MSOX4034A-04-S

# Safety Service Note

## MSOX4034A Mixed Signal Oscilloscope: 350 MHz, 4 Analog Channels Plus 16 Digital Channels

### POSSIBLE "SHOCK" HAZARD

**Situation:**

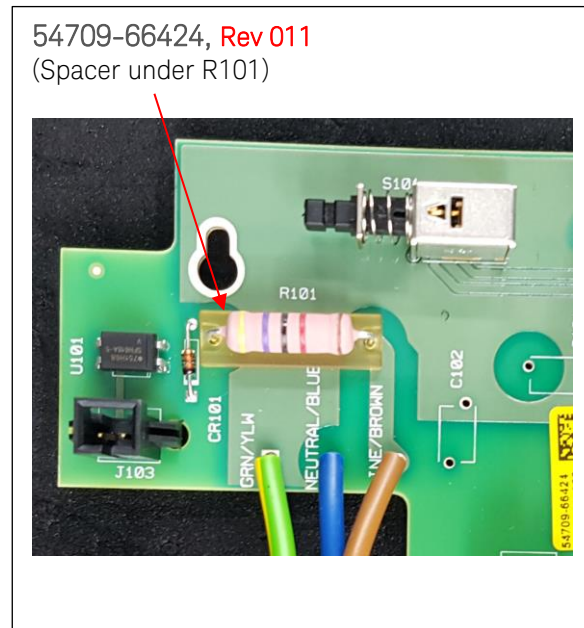
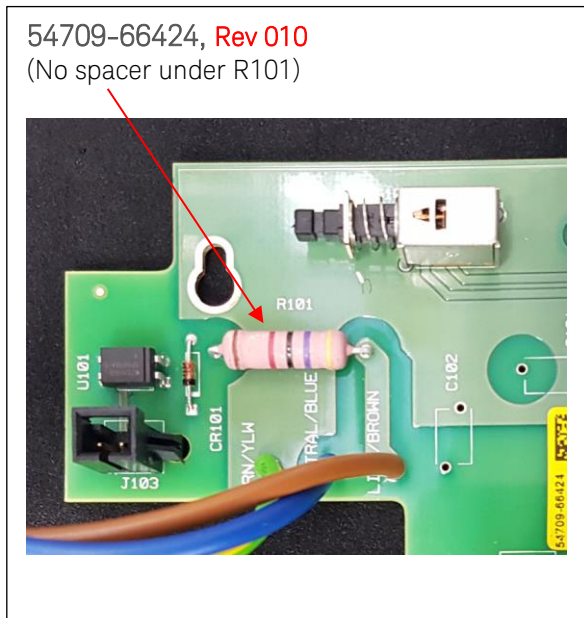
Over the past month, Keysight observed failures during the Routine Safety Test. Investigation found a recently changed R101 resistor, from a 39K ohm part to a new 47K ohm part is against the printed circuit board ground plane and insulation breakdown may cause a safety concern. This issue is limited to the serial numbers listed above.

While the oscilloscope has technically passed all testing and meets product specifications, in an abundance of caution Keysight is recalling and repairing these specific oscilloscopes to ensure the oscilloscope meets the specifications required for Basic insulation by the IEC/UL/CSA 61010-1 standard.

Keysight addressed the issue by placing a spacer under the R101 resistor and updated the 54709-66424 line filter board from rev 010 to rev 011 to reflect the change. The rework on the oscilloscope, performed by a Keysight Service Center, replaces the rev 010 line filter board (54709-66424) with the rev 011 line filter board as specified in the Keysight InfiniiVision 4000 X-Series Oscilloscope Service Guide.

- Perform HiPot.
- Replace the 54709-66424, rev 010 line filter board with 54709-66424, version 011 line filter board as specified in the Keysight InfiniiVision 4000 X-Series Oscilloscope Service Guide. The difference between the two revisions is that rev 011 has a spacer under the 47K resistor.
- Perform HiPot test
- Perform Hardware Self Test: Utility (key) → Service (softkey) → Hardware Self Test (softkey)
- Do Performance Verification (PV) as specified in the Keysight InfiniiVision 4000 X-Series Oscilloscope Service Guide
  - If PV fails, perform User Calibration redo PV
